IRN NO:  <p style="text-align: center;"><b>57000-0001</b></p>	<p><b>ISS PAYLOAD OFFICE IRN/PIRN/EXCEPTION FORM</b></p>	<p><b>(Page 1 of 28)</b></p> <hr/> DATE PREPARED: 5-31-01								
Doc. No.,      SSP 57000, Revision E Rev. & Title:    Pressurized Payloads Hardware Interface Requirements Document		PIRN NO: 57000-NA-0205A, 57000-NA-0198A, 57000-NA-0203, 57000-NA-0208, 57000-NA-0222, 57000-NA-0235A								
(PIRN TITLE): <p style="text-align: center;">Incorporation of P/IRNs into SSP 57000</p>										
ORIGINATOR: Name:      Tom Gallagher Agency:    Boeing/TBE Phone:     (281) 336-4074 Fax:	PIRN Type: <i>Check One</i> <input type="checkbox"/> Standard PIRN <input type="checkbox"/> Exception	<i>For Payload Office Use Only</i> <input type="checkbox"/> Exceedance <input type="checkbox"/> Deviation <p style="text-align: center;">Waiver</p>								
UTILIZATION CHANGE ENGINEER.: Name:      Wade Geiger Agency:    Boeing Phone:     (281) 336-4284	<b>SSCN/CR:</b> SSCN 004176, SSCN 003970	RELATED PIRN NO.: N/A								
Agency Tracking No.:	SYSTEM/ELEMENT AFFECTED:									
REASON FOR CHANGE: (INCLUDE APPLICABLE ICAP NUMBER) SSCD #004176, SSCD# 003970										
PARAGRAPHS, FIGURES, TABLES AFF

**FIGURE 3.2.2.3-1 U.S. RPCM SOFT START/STOP CHARACTERISTICS**

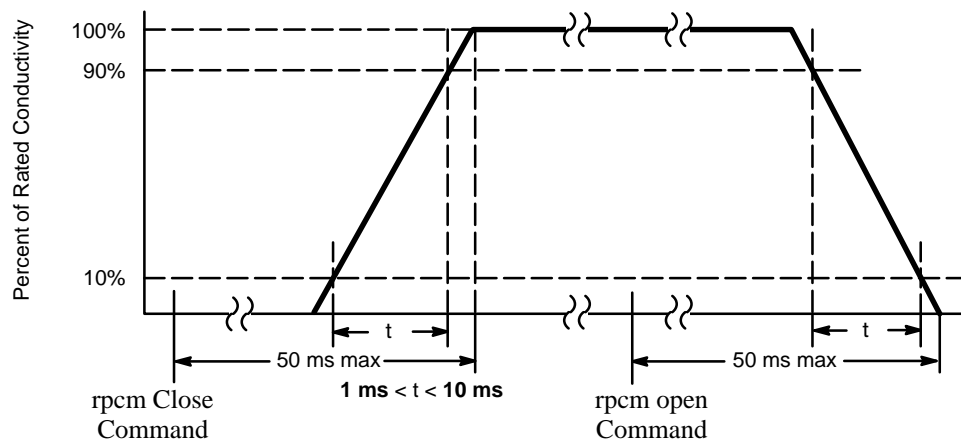
An integrated rack connected to Interface B or EPCE connected to Interface C shall initialize with the soft start/stop performance characteristics when power is applied, sustained, and removed by control of remote power control switches. The soft start/stop function, active only when the Remote Power Controller (RPC) is commanded on or off, is limited to 100 amps/ms, or less, by the RPC output. The response of the soft start/stop function is linear for resistive loads for 1 to 10 ms for U.S. LAB feeds, 1.5 to 5 ms for JEM 50 amp main feeds, 1.5 to 5 ms for JEM 25 amp main feeds, 0.1 to 5 ms for JEM 10 amp auxiliary feeds, and 0.1 to 50 ms for APM feeds between 10% and 90% of rated current level.

Note: Soft start/stop characteristics of U.S. standard RPCMs are shown in Figure 3.2.2.3-1.
